LOS ALTOS TEMPORARY ACCESS DURING CONSTRUCTION

Date: 11/22/2022 **Author:** DARRELL ASHLEY **Project:** JAYNES
OWNER: CITY OF ALBUQUERQUE

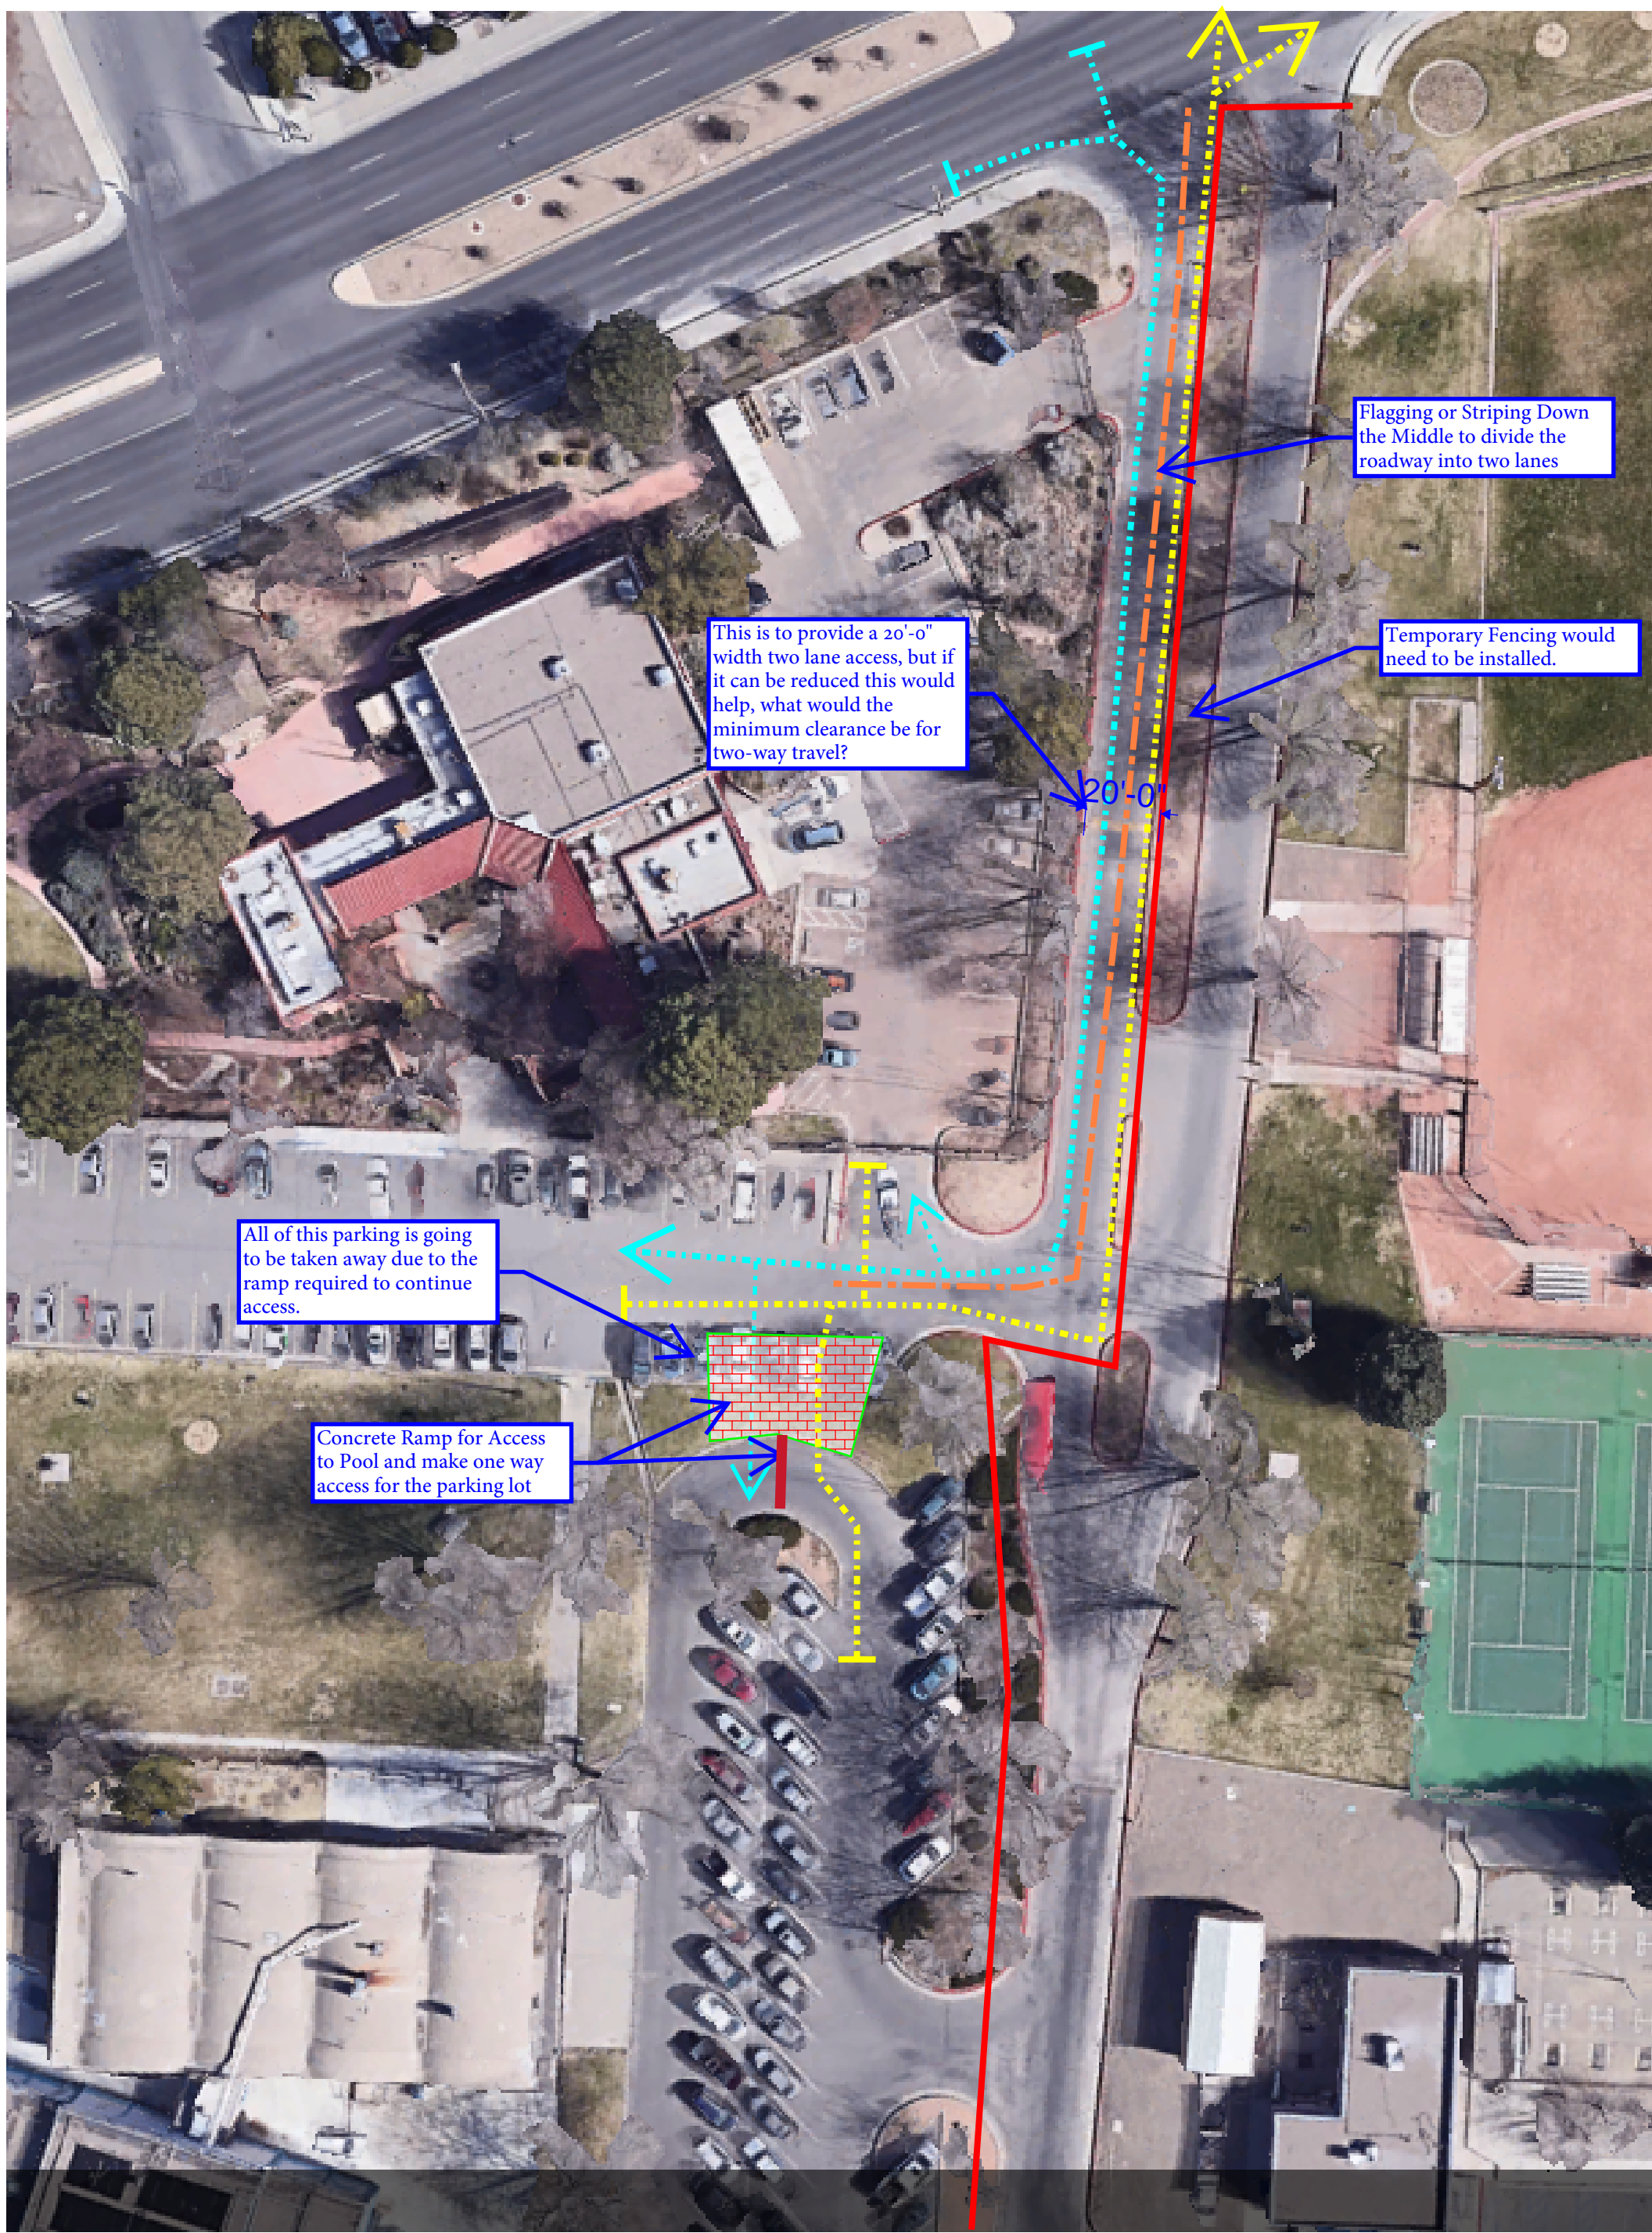
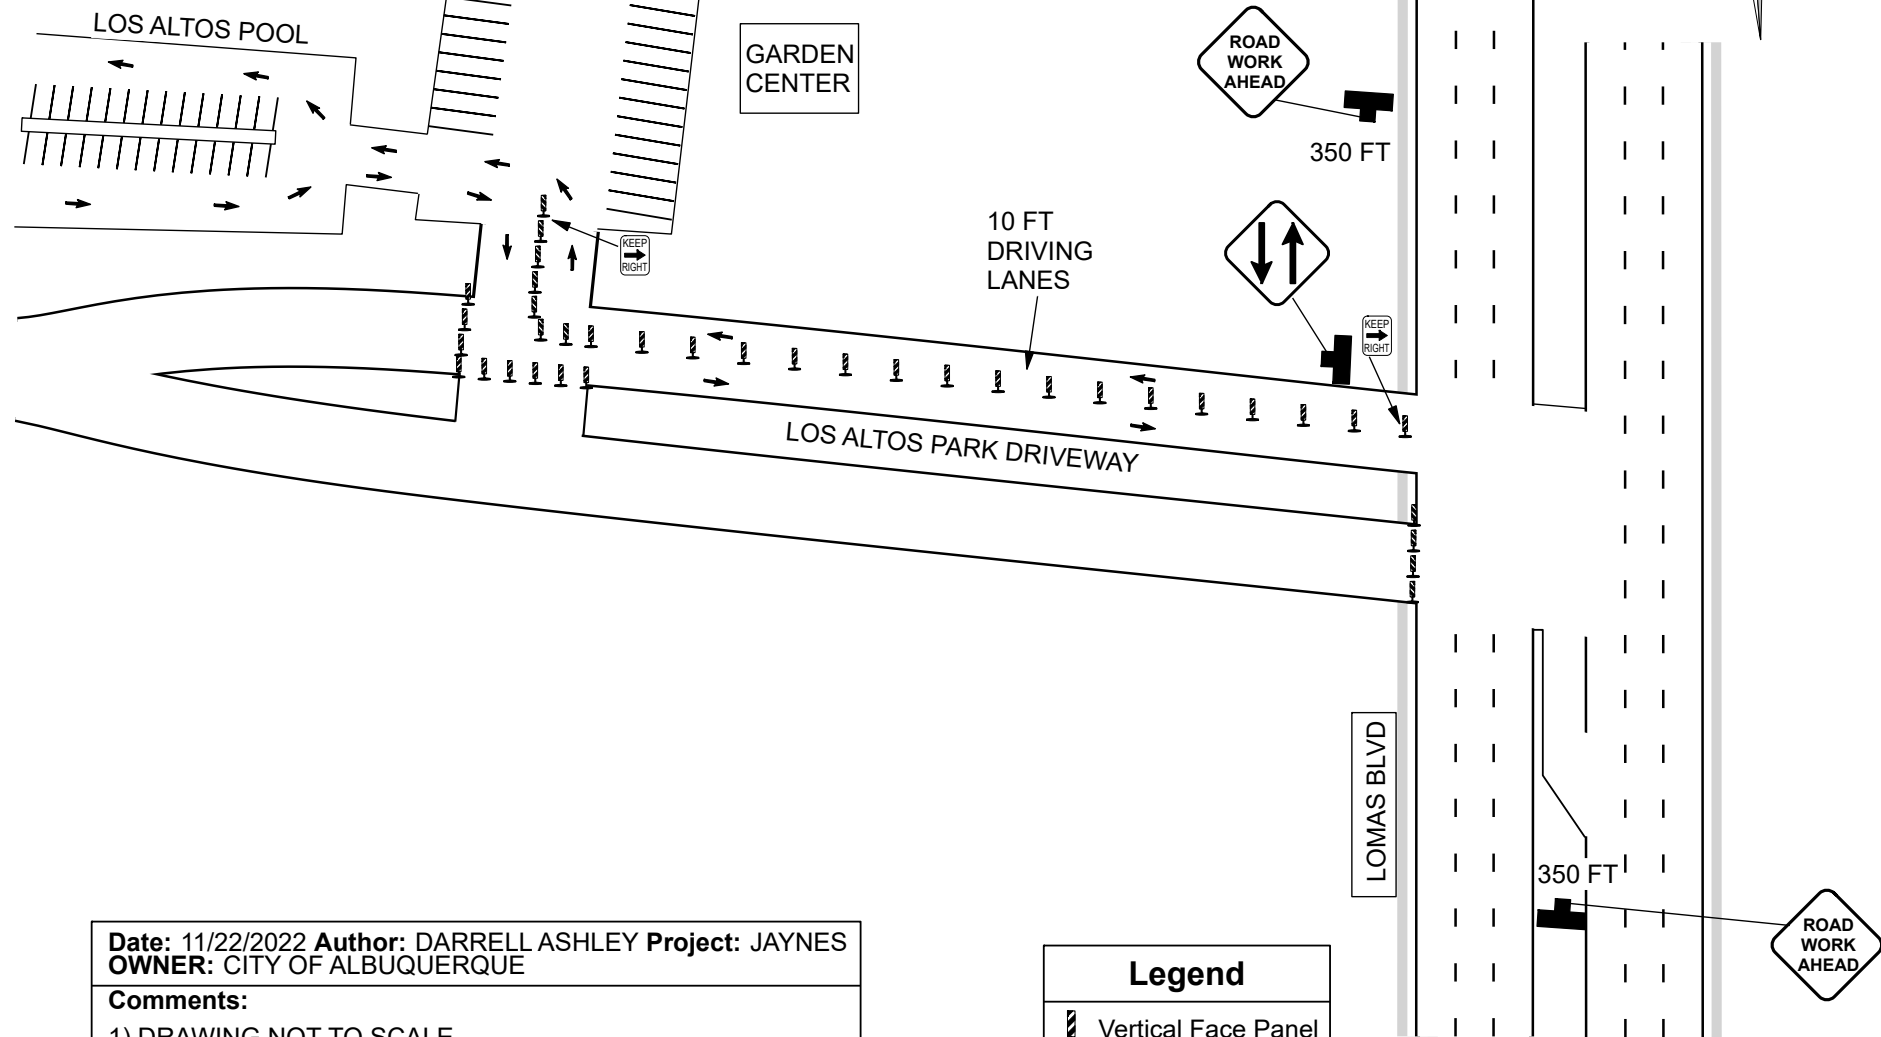
Flagging or Striping Down the Middle to divide the roadway into two lanes

Temporary Fencing would need to be installed.

This is to provide a 20'-0" width two lane access, but if it can be reduced this would help, what would the minimum clearance be for two-way travel?

All of this parking is going to be taken away due to the ramp required to continue access.

Concrete Ramp for Access to Pool and make one way access for the parking lot
